Service Kit 753-05343

REF: MTD-034

Subject: Upper Transmission Drive Belt Path Alignment

Models Affected: 2006 Model Year 600-609 Series AutoDrive Units built between November 1, 2005 and February 17, 2006

FIGURE 2

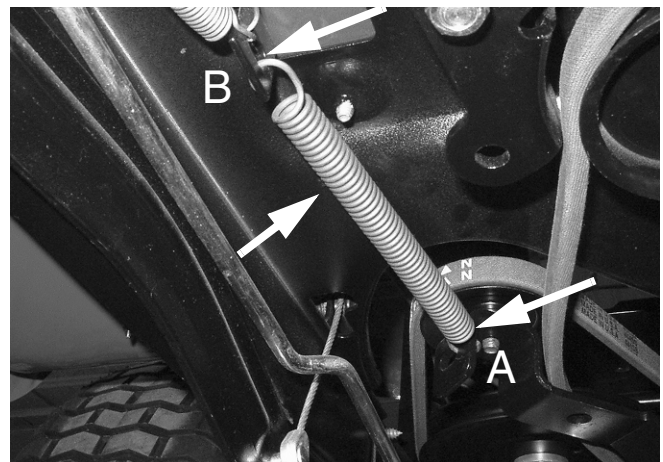
3. Refer to Figure 2. From the underside of the rider, disconnect the extension spring, 732-0384, that provides upper transmission belt idler tension, from the hook on the lower frame and the transmission's upper belt tensioning idler. Discard the spring.

18. Slip the Split Plastic Conduit, Item 6, onto the new Extension Spring, Item 9. Install the new spring as shown in Figure 2.

FIGURE 6

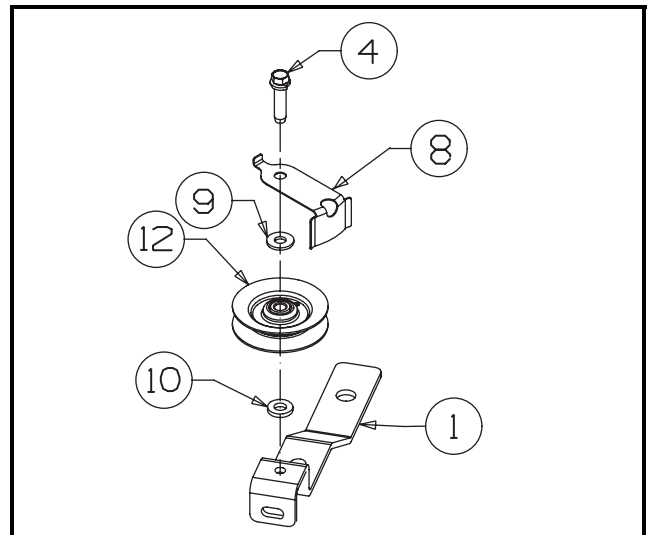
12. Assemble the "V" Type Idler Pulley, Item 12, Belt Guard, Item 8, and Flat Washers, Items 9 and 10, to the Idler Bracket, Item 1, using SEMS TapTite Screw, Item 4. Do not tighten the 3/8" mounting screw. Leave about two threads from tight, so that the belt can be installed in a later step.

FIGURE 7

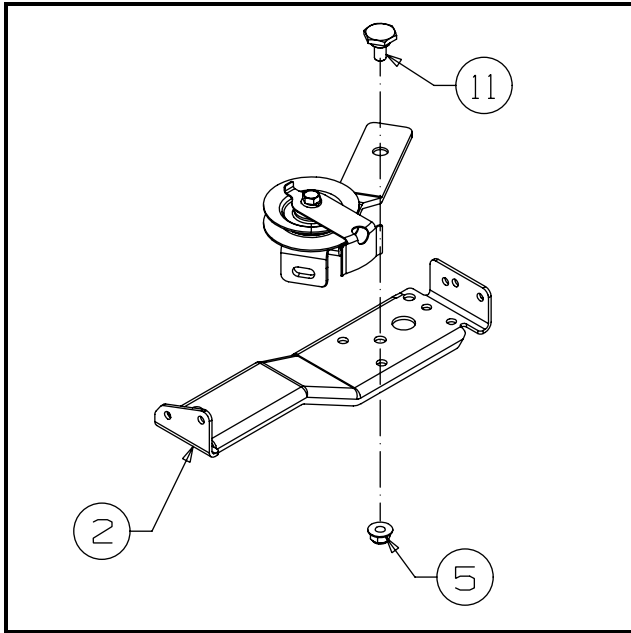
13. Assemble the new Idler Bracket, Item 1, subassembly onto the new Torque Bracket, Item 2, using the new Shoulder Screw, Item 11, and Flange Lock Nut, Item 5, as shown in Figure 7.
